Minute No. 666
Report – Standing Policy Committee on Property and Development, Heritage and Downtown Development – October 10, 2017

Item No. 2 Request to Amend Development Agreement Conditions for File DASZ 3/2016 (AG 3/2016)
(Transcona Ward)

Title: **REQUEST TO AMEND DEVELOPMENT AGREEMENT CONDITIONS FOR FILE DASZ 3/2016 (AG 3/2016)**

APPENDIX "B" – PROPOSED SCHEDULE G MAP TO AG 3/2016

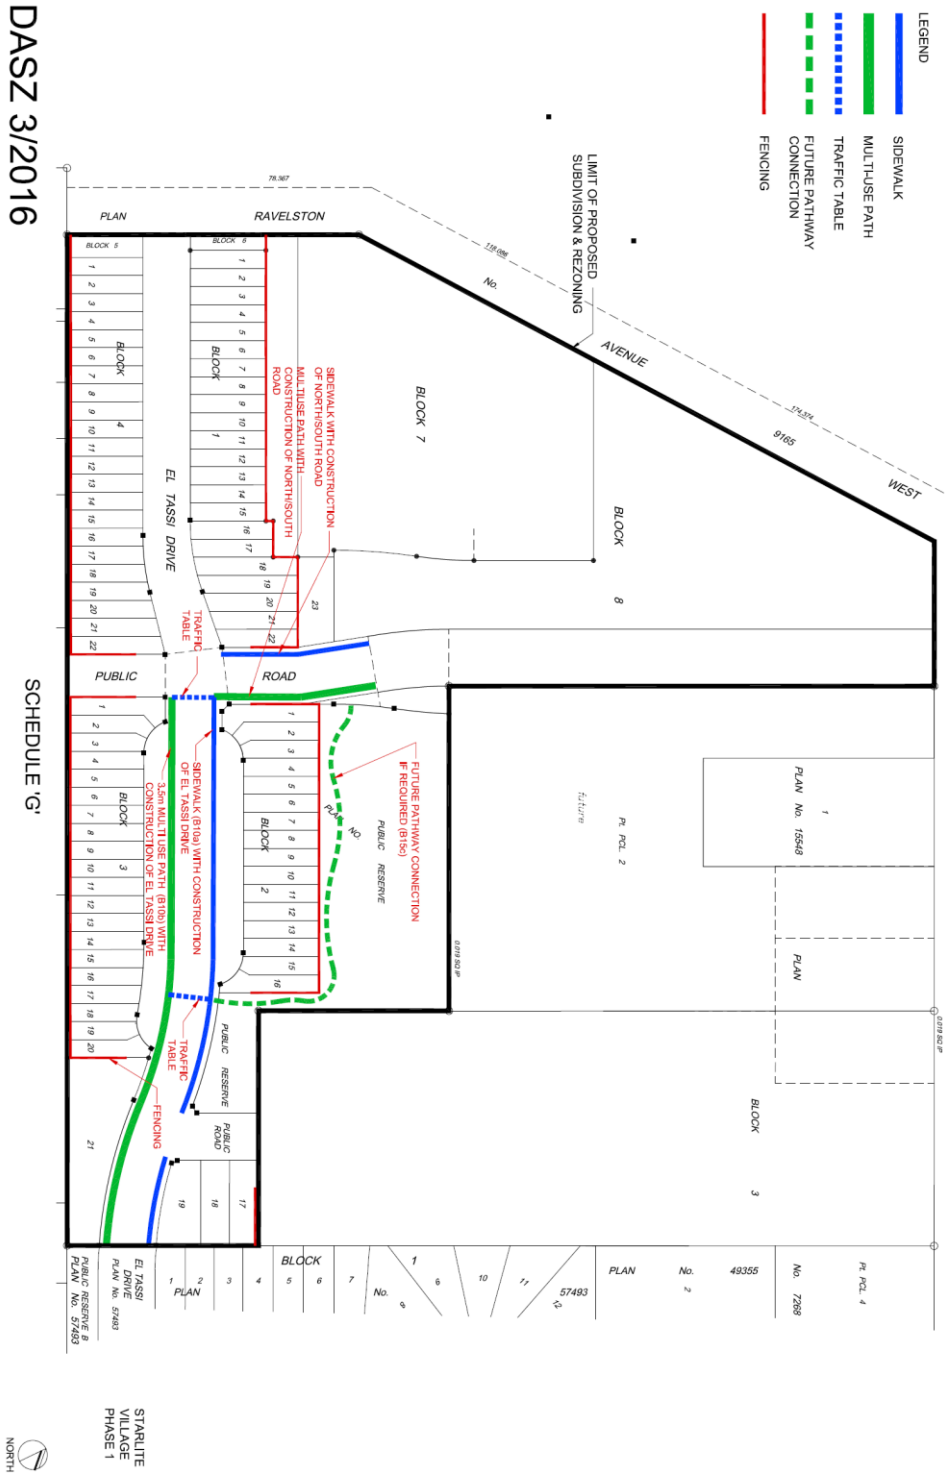
Pursuant to Development Agreement AG 3/2016, the Developer is required to, at no expense to the City, construct an east-west multi-use pathway along the proposed extension of El Tassi Drive. The Developer is requesting that this condition be amended so that the pathway would only extend to the future north/south road (identified as "Public Road" in Appendix "B" to this report).

The Winnipeg Public Service is opposed to this request as this pathway is required under the Transcona West Area Structure Plan and is the only east-west walking and cycling path between Reenders Drive and Concordia Avenue with connectivity to the only crossing of Lagimodiere Boulevard at Almey Avenue.

> Comments from Public Works
> Public Works does not support the proposed amendment. The multi-use path along El Tassi Avenue is required under Map 4 of the Transcona West Area Structure Plan, By-law No. 215/2006.
> Public Works considers the multi-use path along El Tassi Avenue important because it is the only east/west walking and cycling path between Reenders Drive and Concordia Avenue with connectivity to the only crossing of Lagimodiere Boulevard at Almey Avenue.
> Furthermore, the multi-use path along El Tassi Avenue will serve pedestrians and cyclists travelling to and from Crocus Meadows and neighbouring developments to the east and northeast to the crossing of Lagimodiere Boulevard at Almey Avenue.

1) **Schedule "C", Section I – Servicing, Clause 10 Sidewalk/Multi-Use Pathways, b)**
That this clause be be amended as follows:
The Developer shall, at no expense to the City, construct an east-west multi-use pathway along the proposed extension of El Tassi Drive to the **'future N/S road'**, to the satisfaction of the Director of Public Works. The Developer shall submit options to the Public Works Department for review and approval. The Developer shall modify the right-of-ways if required, to the satisfaction of the Director of Public Works.

2) **Schedule G**
Delete Schedule 'G' and replace with attached Schedule 'G'.

1. That the Developer's request to amend Development Agreement (AG 3/2016) Clause 10, b) of Schedule "C" by adding the words "future N/S road", be approved, as outlined in Appendix A.

2. That the Developer's request to amend Development Agreement (AG 3/16) to delete and replace the Schedule "G" Map with an amended Schedule "G" listed as Appendix B of this report, be approved, subject to the following:

A. That the Developer install a sidewalk on the south side of El Tassi Drive, along Blocks 4 and 5, as outlined in blue on Appendix C.
